**E-54 Regional Lift Station - RFCSP
Solicitation Number: CO-00537
Job No.: 22-2502**

**ADDENDUM 2
October 25, 2022**

SAWS JOB NO.	22-2502
JOB NO.	11500-51
DATE	SEPTEMBER 2022
DESIGNER	KB
CHECKED	KB DRAWN GL
SHEET	E10.00

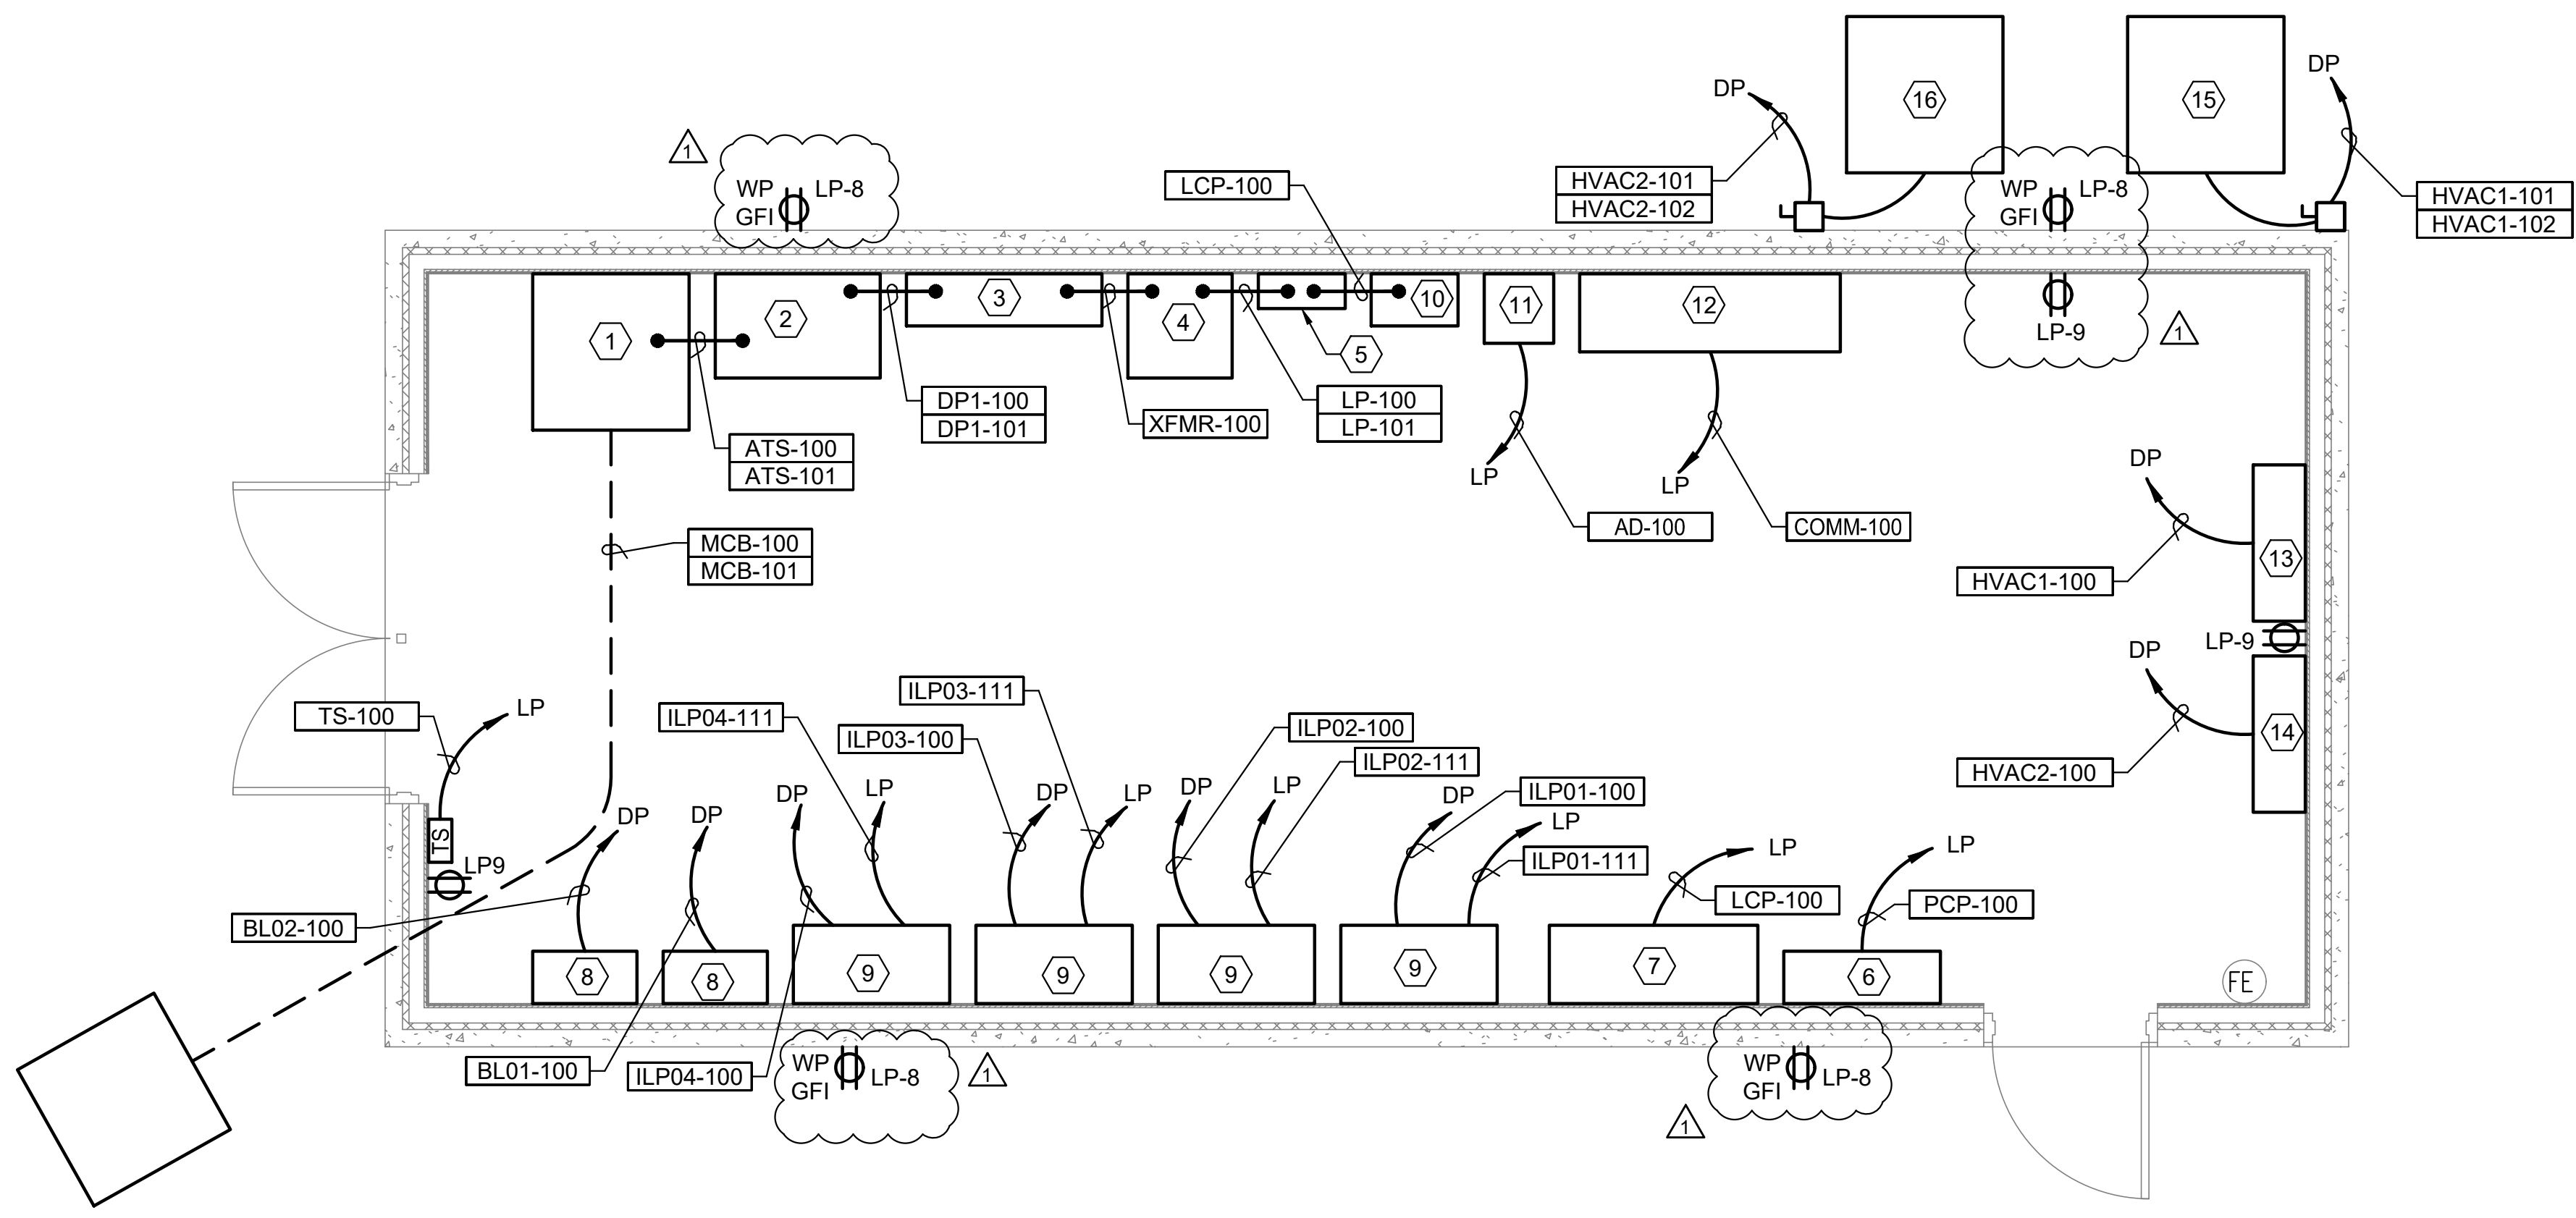
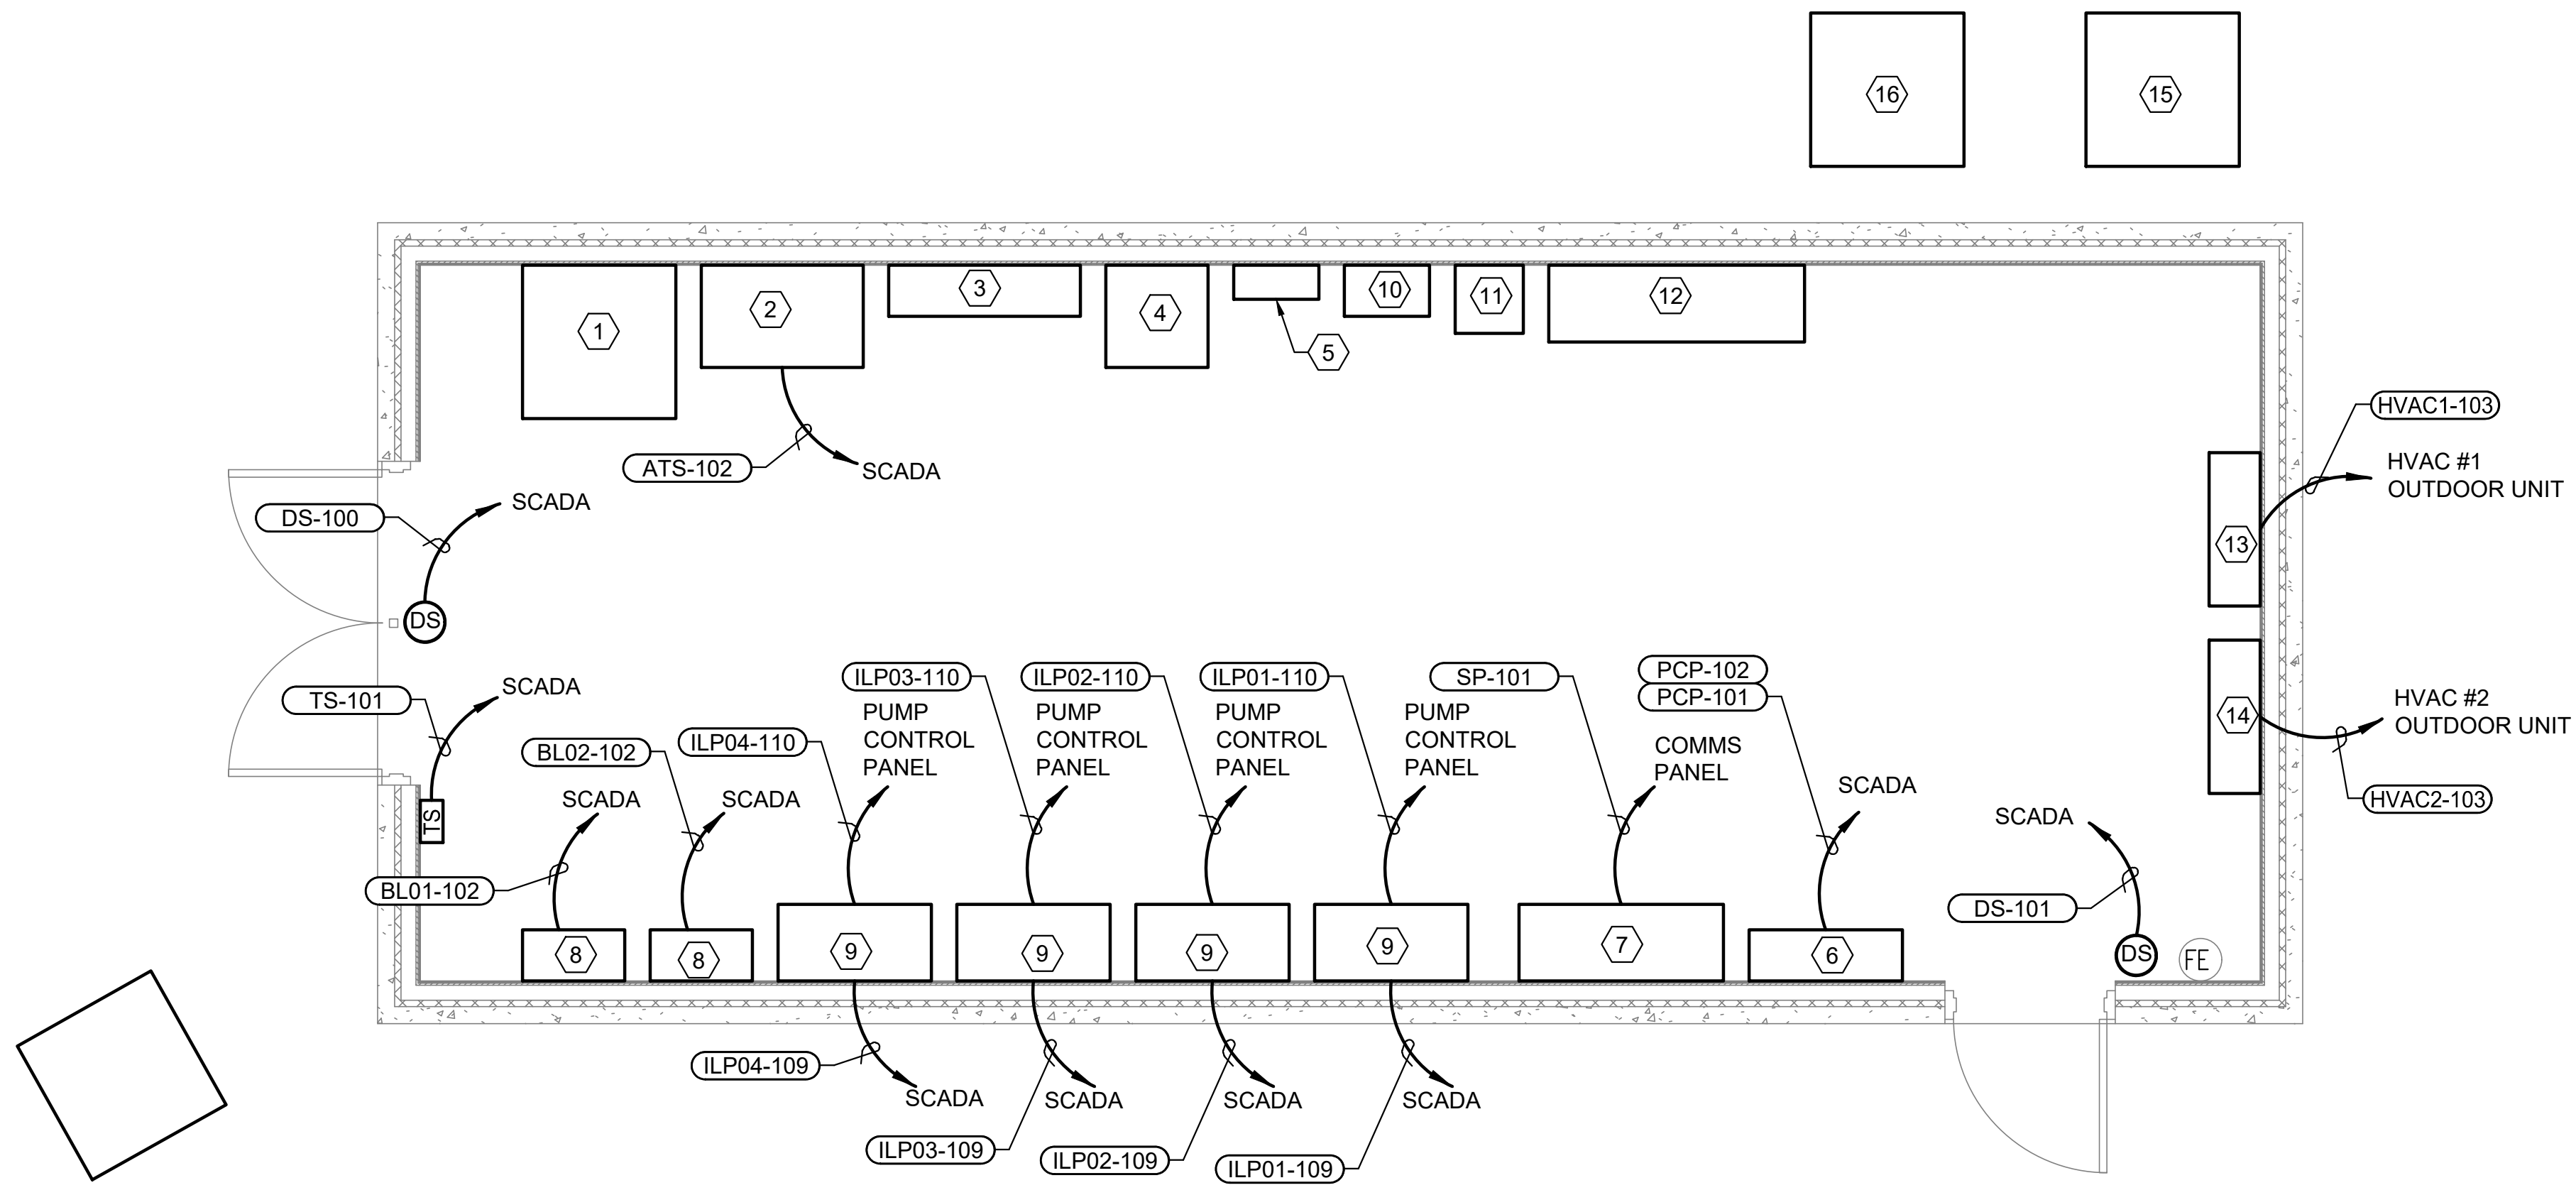
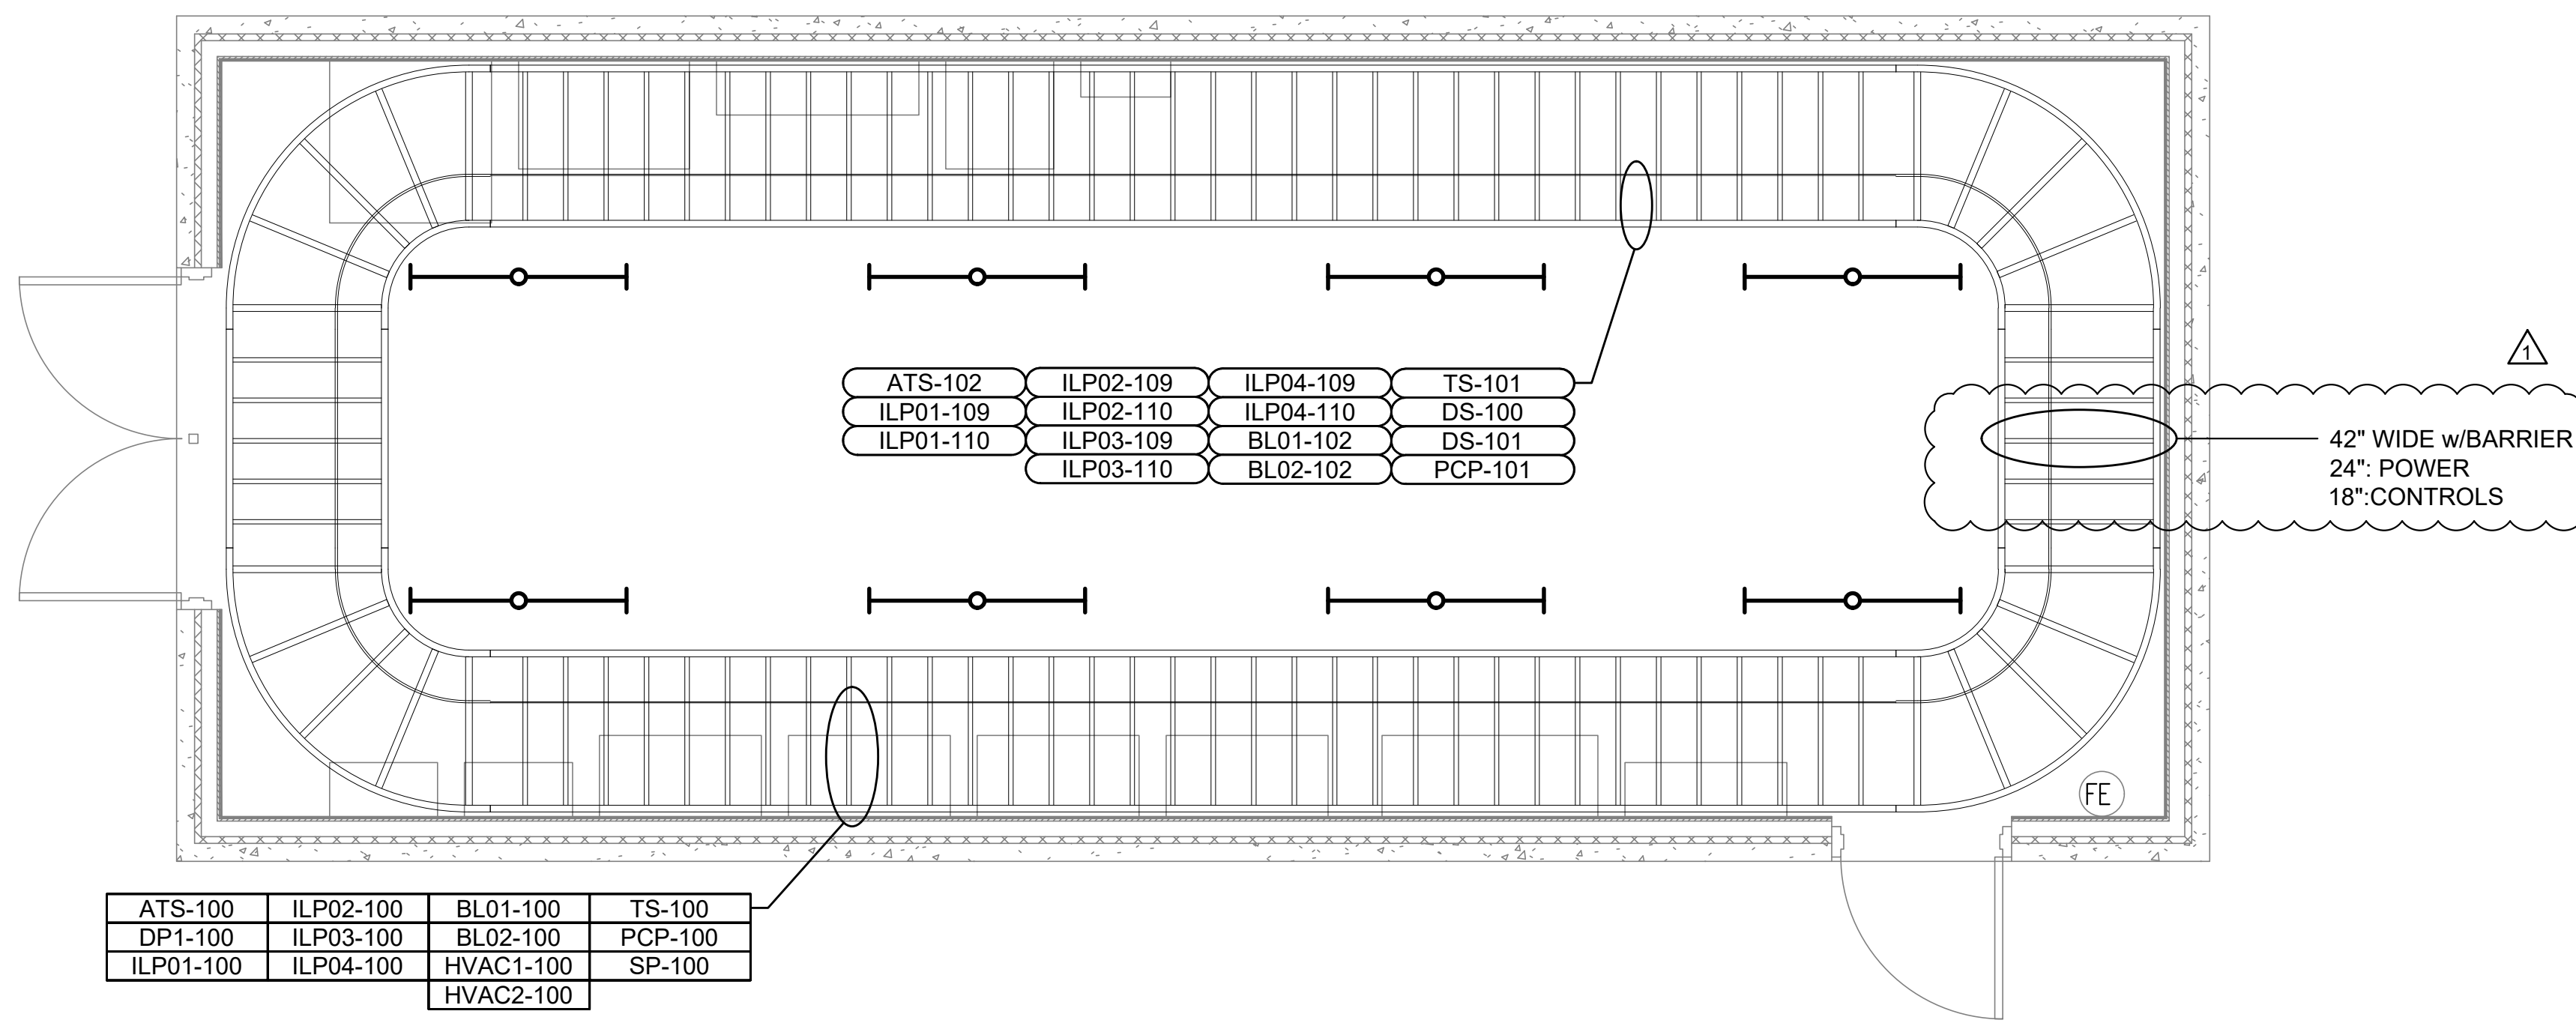
LP circuit #8 shows to be for the Building Exterior Receptacle, but none are shown on sheet E10.00, please clarify.

RESPONSE: Sheet E10.00 revised to show the addition of exterior receptacles. Sheet E10.00 also shows additional interior receptacles. See Changes to the Plans #11.
